HISTORIC LANDMARK COMMISSION Application for a Certificate of Appropriateness February 28, 2022 HR-2022-002112 Robertson/Stuart & Mair Historic District 1104 E. 10th Street

Construct an accessory dwelling unit.

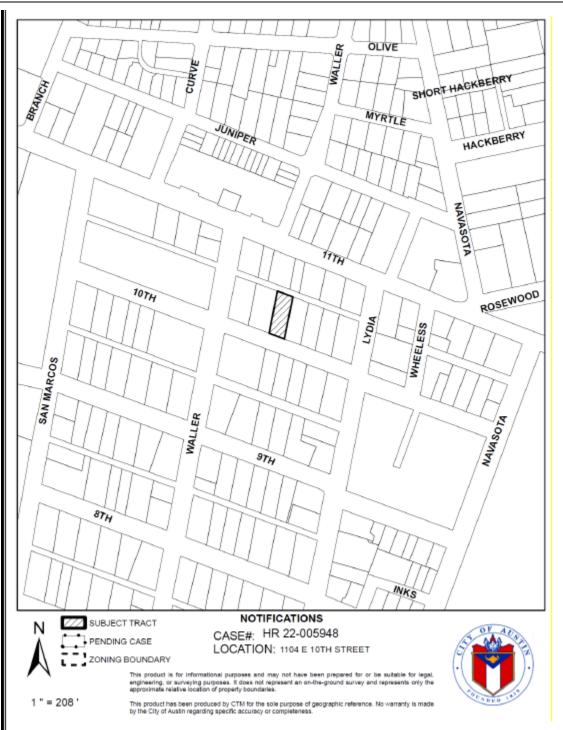
The proposed ADU is differentiated from the main house by its two-story height, irregular shape, irregular shed roof, and modern fenestration and cladding materials. While the exterior cladding and fenestration is mostly compatible, the building's projecting eave at the main elevation, the spiral staircase, and the shed roofline are less compatible.

Request that the applicant omit the spiral staircase and projecting eave from the front of the ADU in favor of more understated design choices, then approve the application.
